Project	IEEE 802.21a
	https://mentor.ieee.org/802.21
Title	A Summary of Raised Issues in the Current Existing Options
DCN	21-09-00xx-00-0Sec
Date Submitted	May 11, 2010
Source(s)	Lily Chen (NIST)
Re:	Discuss at IEEE 802.21 session #37, May 10-13, 2010
Abstract	This document summarizes the raised issues in the current options for work item 1 and work item 2.
Purpose	To initial discussions on these issues at meeting #37.
Notice	This document has been prepared to assist the IEEE 802.21 Working Group. It is offered as a basis for discussion and is not binding on the contributing individual(s) or organization(s). The material in this document is subject to change in form and content after further study. The contributor(s) reserve(s) the right to add, amend or withdraw material contained herein.
Release	The contributor grants a free, irrevocable license to the IEEE to incorporate material contained in this contribution, and any modifications thereof, in the creation of an IEEE Standards publication; to copyright in the IEEE's name any IEEE Standards publication even though it may include portions of this contribution; and at the IEEE's sole discretion to permit others to reproduce in who

Figure 1. EAP over MIH for proactive authentication – Work Item 1.

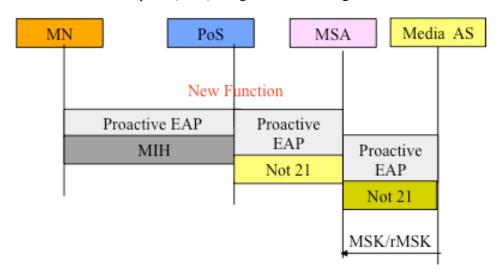
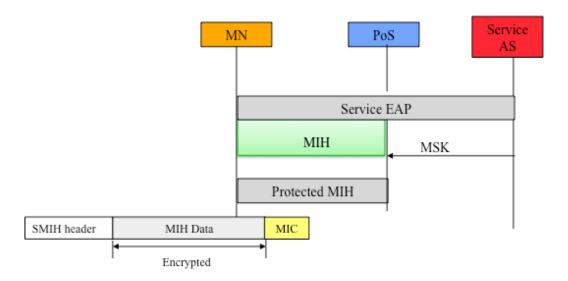
The issue is how PoS can distinguish the two situations:

- 1. As an authentication message routing device (do not process, only forward);
- 2. As an authenticator (process).

1. Can we add different flags in MIH message for proactive media authentication and for service authentication?
